**CALIFORNIA REGIONAL WATER QUALITY CONTROL BOARD  
LAHONTAN REGION**

**MEETING OF JUNE 8, 2011  
Barstow**

**SUBJECT: FACILITATED STUDY SESSION: UPDATE ON ACTIONS BY  
PACIFIC GAS AND ELECTRIC COMPANY TO REMEDIATE  
GROUNDWATER CONTAMINATION AND ADDRESS THE  
EFFECTS ON BENEFICIAL USES DUE TO A HISTORIC  
RELEASE OF HEXAVALENT CHROMIUM FROM ITS HINKLEY  
COMPRESSOR STATION, SAN BERNARDINO COUNTY**

FIGURE:  
**1**  
 DATE: 03/28/11

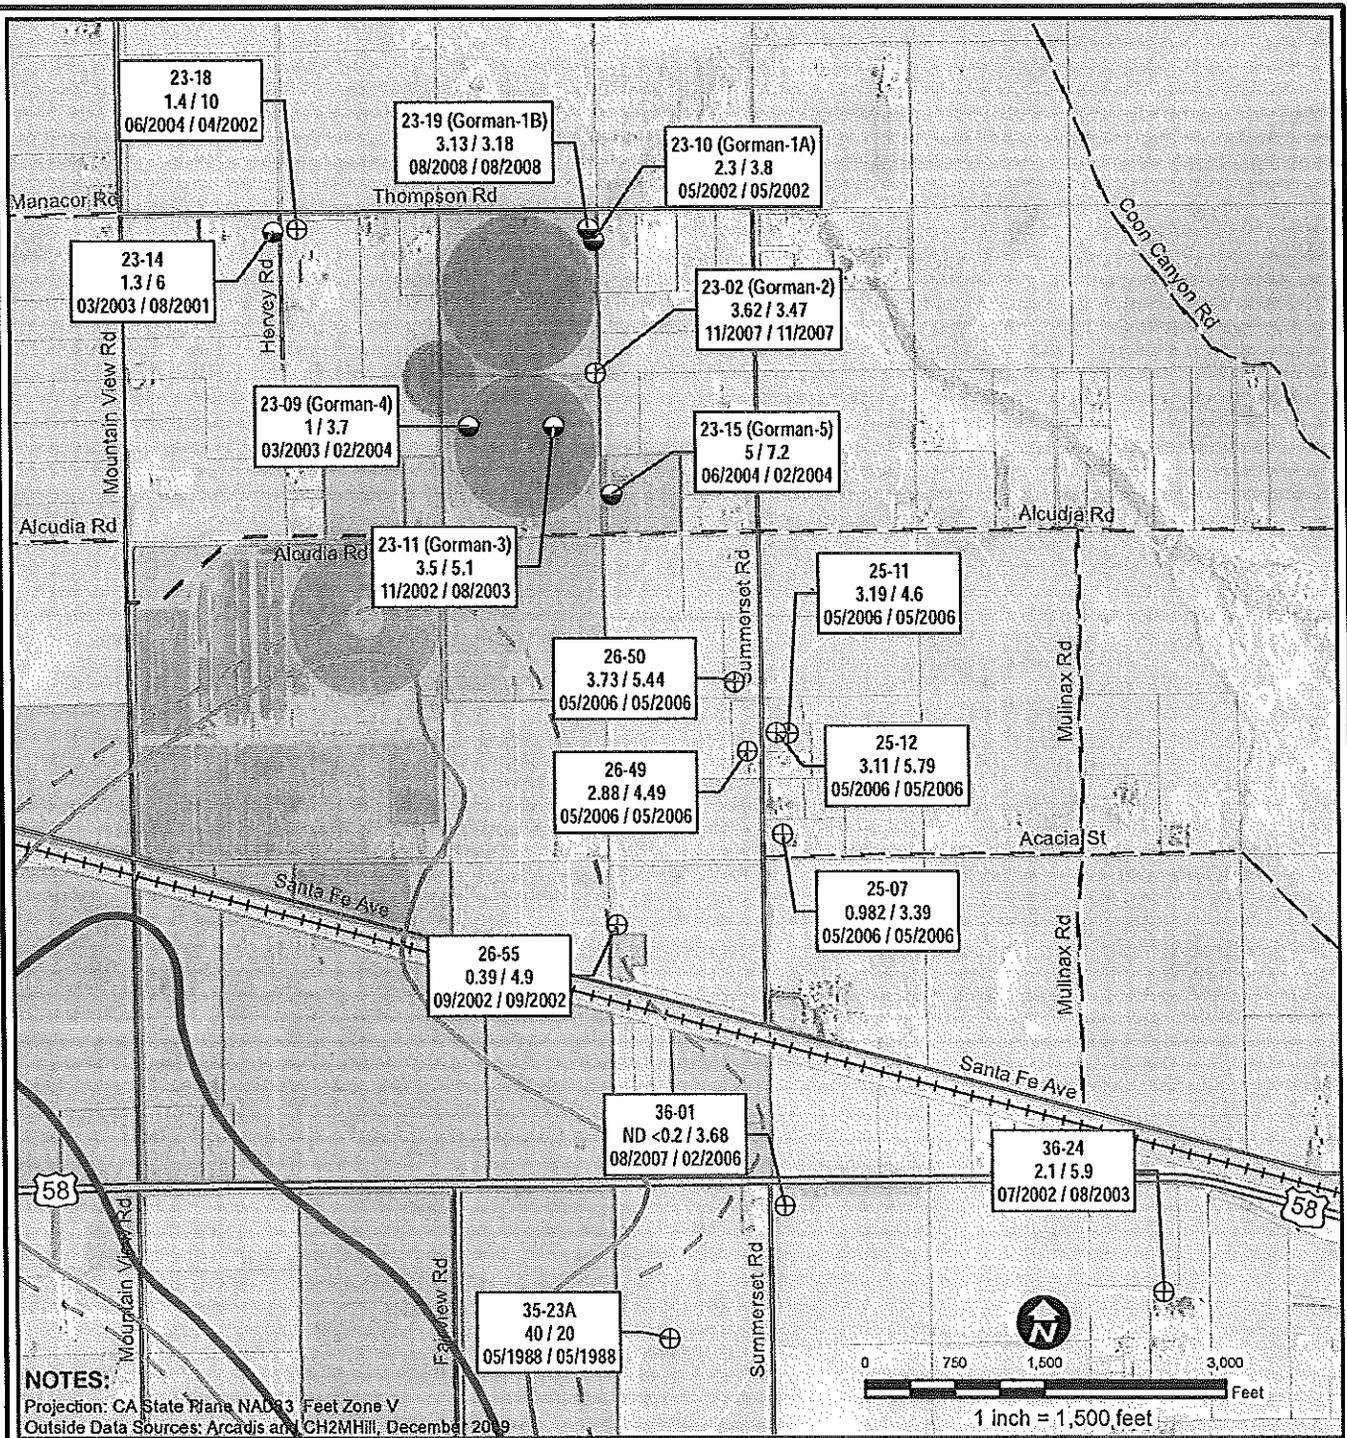
Prior to 2008, there was evidence of chromium-affected groundwater outside the 2008 plume boundary, particularly to the north (Gorman property) and northeast (Summerset Road area). These data were all reported to Water Board staff at the time the data were collected. The attached Figure 1 illustrates these conditions, which are summarized as follows:

**Summerset Road Area Wells** –Several long screen domestic wells along Summerset Road were sampled in 2006 and showed chromium concentrations exceeding background conditions (wells

25-07, 26-49, and 26-50). These data clearly demonstrate the presence of chromium at concentrations above natural background levels extending east beyond the limits of the 2008 plume boundary.

Since March 2010, PG&E has conducted additional investigations on the Gorman property and in the Summerset Road area, including re-sampling the referenced domestic wells that exceeded background limits in 2006 and installing additional monitoring wells. The results suggest similar concentrations in the new monitoring wells compared to the historic data from the Gorman pumping wells and the 2006 data at the three referenced domestic wells along Summerset Road. These data support a conclusion that the plume boundary extended further north and east than depicted in the 2008 plume boundary, and the plume boundary did not expand to these areas after 2008.
